**CBE, Sierra Club, Center, ForestEthics et al. Comments on the Revised Draft
Environmental Impact Report for the Phillips 66 Company Rail Spur Extension and Crude
Unloading Project**

**Previous Comments and Materials Submitted for the Draft Environmental Impact Report
of the Project.**

RE: Comments to the Draft Environmental Impact Report (“DEIR”) for the Phillips 66 Company Rail Spur Extension Project (“Project”)

Figure 1
Overall Existing Rodeo Refinery
Block Flow Diagram

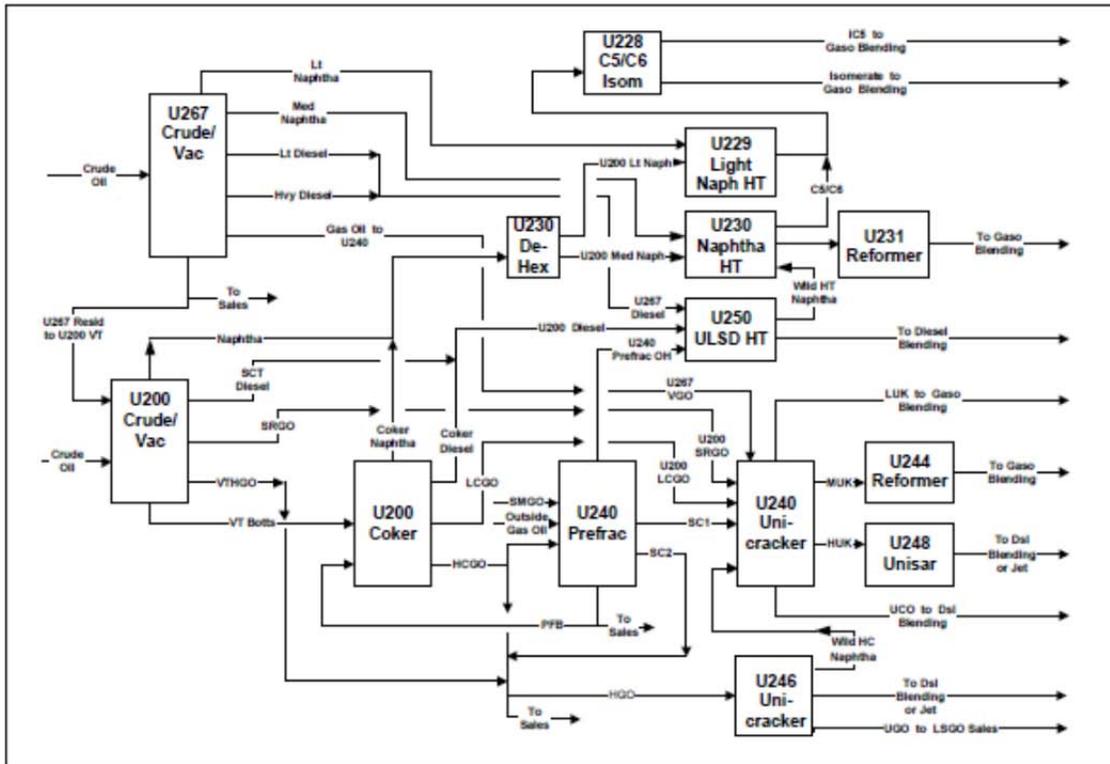
The link between the Santa Maria Refinery semi-refined products (gas oil, naphtha) and the Rodeo Propane Recovery Project is clearly shown in the Rodeo Refinery block flow diagrams from the Rodeo Propane Recovery DEIR. The block flow diagram for the existing Rodeo Refinery (Rodeo DEIR Figure 3-4) shows “SMGO” entering the Refinery at the U-240 Prefractionator unit (Prefrac unit). See Rodeo DEIR, p. 3-12 (“Heavy gas oil (HGO) streams from Unit 200 and HGO purchased from outside of the Refinery are fractionated in the Unit 240 prefractionator.”) SMGO is Santa Maria Gas Oil. This Rodeo DEIR figure is reproduced here as Figure 1 for ease of reference. The U-240 Prefrac unit at Rodeo separates Santa Maria gas oil and other gas oils into lighter hydrocarbon fractions that are currently blended into the Rodeo Refinery Fuel Gas, shown in Rodeo DEIR Figure 3-5 (see lower left hand corner, blue arrow labeled U-240/244/248 S-RFG being routed to U-240 Fuel Gas Treating), but which will be further processed into propane and butane in new units added to the Rodeo Refinery as part of the Propane Recovery Project.

Figure 2
Proposed Rodeo Refinery
Fuel Gas System Block Flow Diagram

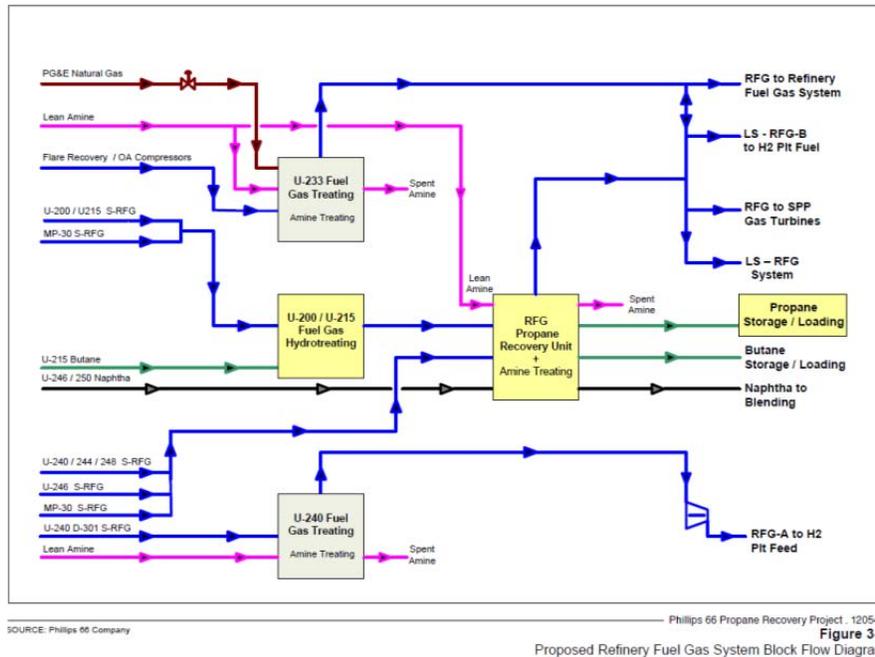
Under the Propane Recovery Project at Rodeo, the output from the Prefrac unit is sent to the proposed “RFG Propane Recovery Unit” instead of the Refinery Fuel Gas system. This unit is the heart of the Propane Recovery Project. Rodeo DEIR, Table 3-2. Propane and butane are recovered in this unit. This new propane/butane extraction unit is shown in Propane Recovery Project DEIR in Figure 3-6, which is reproduced here as Figure 2 for ease of reference.

The RFG Propane Recovery Unit is the big yellow box in the middle of Figure 2. Blue arrows in the lower left hand corner of Figure 2 identify the inputs to this unit, which are various refinery streams. These streams include “U-240/244/248 S-RFG.” This designation means that Refinery Fuel Gas (RFG) from Unit U-240 is sent to the RFG Propane Recovery Unit. (This stream was formerly sent to the U-240 Fuel Gas Treating Unit. Rodeo DEIR, Fig. 3-6.) As Santa Maria Gas Oil (SMGO) is one of the inputs to Unit U-240, changes at the Santa Maria Refinery would be transmitted directly to the Propane Recovery Project via the U-240 Prefrac Unit at Rodeo.

Figure 1
Overall Existing Refinery Block Flow Diagram

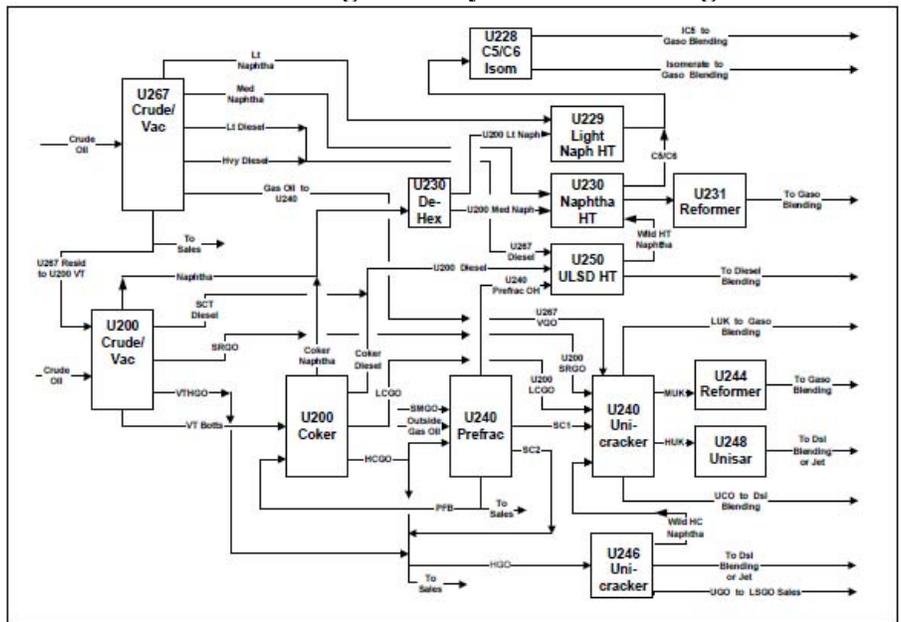
This link is clearly shown in the Rodeo Refinery block flow diagrams in the subject Rodeo Refinery DEIR. The block flow diagram for the existing Rodeo Refinery, DEIR Figure 3-4, shows "SMGO" entering the Refinery at the U-240 Prefractionator unit (Prefrac unit). DEIR, p. 3-12 ("Heavy gas oil (HGO) streams from Unit 200 and HGO purchased from outside of the Refinery are fractionated in the Unit 240 prefractionator."). SMGO is Santa Maria Gas Oil. This DEIR figure is reproduced here as Figure 1 for ease of reference. The U-240 Prefrac unit separates Santa Maria gas oil and other gas oils into lighter hydrocarbon fractions that are currently blended into the Refinery Fuel Gas, shown in Figure 3-5 (see lower left hand corner, blue arrow labeled U-240/244/248 S-RFG being routed to U-240 Fuel Gas Treating), but which will be further processed into propane and butane in new units added to the Rodeo Refinery as part of the Project.

Figure 2
Proposed Refinery Fuel Gas System Block Flow Diagram

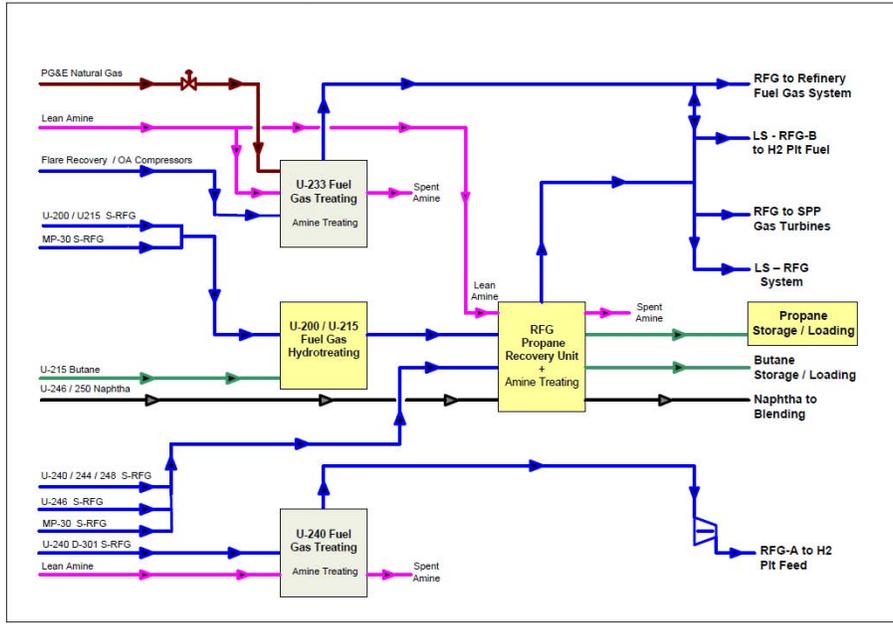
Under the Project, the output from the Prefrac unit is sent to the proposed "RFG Propane Recovery Unit" instead of the Refinery Fuel Gas system. This unit is the heart of the subject Project and is immediately adjacent to the Unit 240 Prefrac unit. DEIR, Table 3-2. Propane and butane are recovered in this unit. This new propane/butane extraction

The RFG Propane Recovery Unit is the big yellow box in the middle of Figure 2. Blue arrows in the lower left hand corner of Figure 2 identify the inputs to this unit, which are various refinery streams. These streams include "U-240/244/248 S-RFG." This designation means that Refinery Fuel Gas (RFG) from Unit U-240 is sent to the RFG Propane Recovery Unit. (This stream was formerly sent to the U-240 Fuel Gas Treating Unit. DEIR, Fig. 3-5.) As Santa Maria Gas Oil (SMGO) is one of the inputs to Unit U-240, changes at the Santa Maria Facility would be transmitted directly to the Project via the U-240 Prefrac Unit.
